E109-24

IBC: 1028.2; IFC: [BE] 1028.2

2024 International Building Code

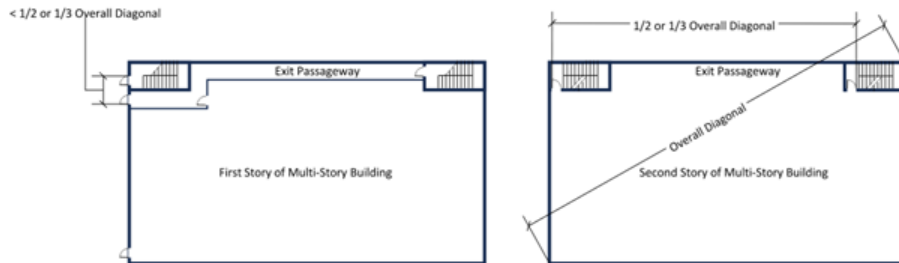
Reason: Although buildings with exit doors directly to the exterior would not have a problem complying with this requirement since the exit doors require comparable separation per Section 1007.1.1, it is entirely possible to have a combination of interior exit stairways and ramps and exit passageways that provide exit discharge points that are close or even adjacent to each other (see illustration below).

Blockage of one exit discharge door would likely cause a blockage to the adjacent, thus denying any means of egress from occupants on the upper stories.

To ensure that occupants on stories other than the level of exit discharge have options to allow safe egress from the building, the code requires that no less than two means of egress be separated by either 1/2 or 1/3 the overall diagonal depending on the presence of a sprinkler system. It makes no sense to then allow these exits to discharge at locations that could be literally adjacent to each other.

[BE] 1028.2 Exit discharge. *Exits shall discharge directly to the exterior of the building. Where two or more exits are required, the termination of not less than two exits at the level of exit discharge shall be placed a distance apart equal to not less than one-half of the length of the maximum overall diagonal dimension of the building or area to be served measured in a straight line between them and to any point along the width of the doorway. The exit discharge shall be at grade or shall provide a direct path of egress travel to grade. The exit discharge shall not reenter a building. The combined use of Exceptions 1 and 2 shall not exceed 50 percent of the number and minimum width or required capacity of the required exits.*
